**Southeast Upper Salt Creek  
Watershed Master Plan**

## Comprehensive Plan Proposed Amendment # 4

**Subject:** *Southeast Upper Salt Creek Watershed Master Plan  
Comprehensive Plan Proposed Amendment #4*

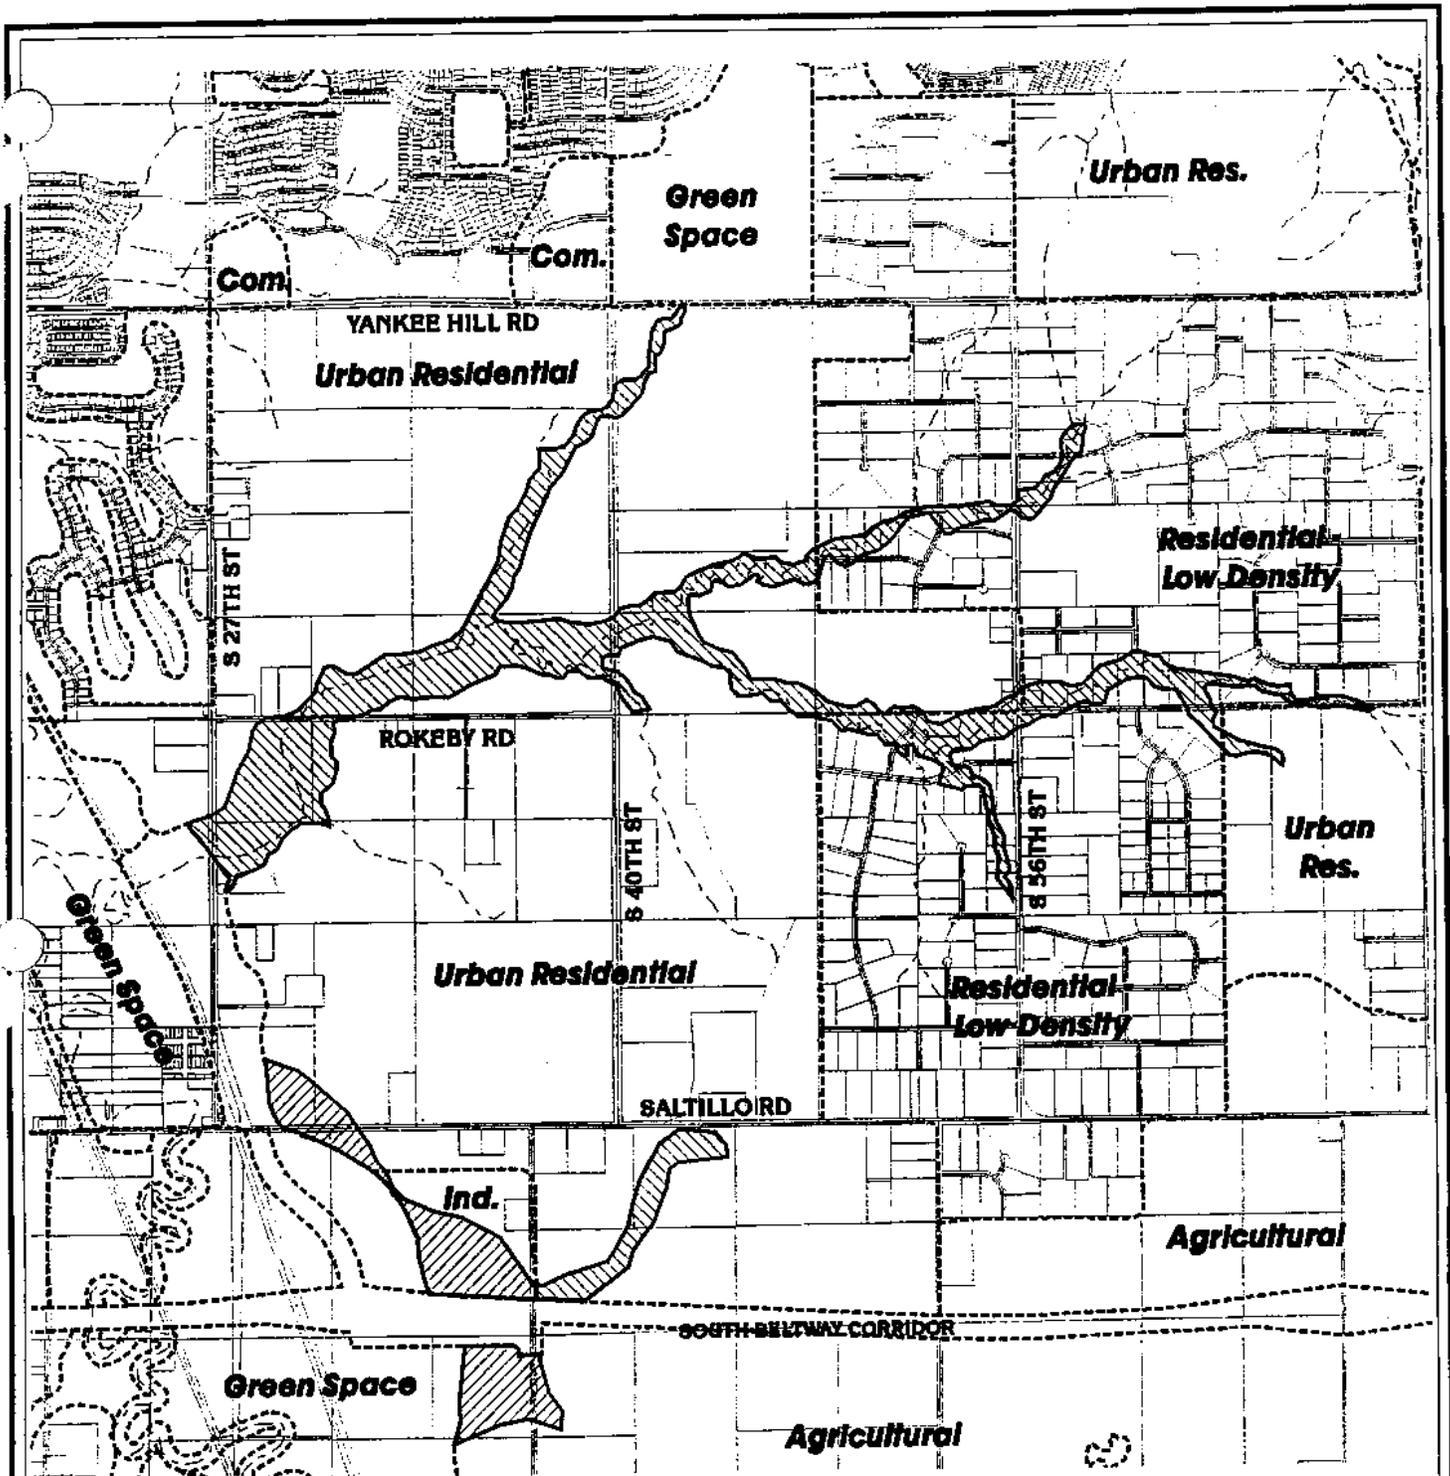
1. Amend the "Lincoln/Lancaster County Land Use Plan", figure on pages F23 and F25, to designate as 'Green Space' and "Agricultural Stream Corridor" the 100 year flood prone area as shown on the attached map.
2. Add the "Southeast Upper Salt Creek Watershed Master Plan, 2003" to the list of approved subarea plans on Page F 156.
3. Add a new section to the end of the Watershed Management section on page F 80 as follows:

- Land Use Boundary
- Res** Land Use Category
-  From Urban Residential, Residential Low Density, and Industrial to Green Space
-  From Urban Residential, Industrial and Agricultural to AG Stream Corridor
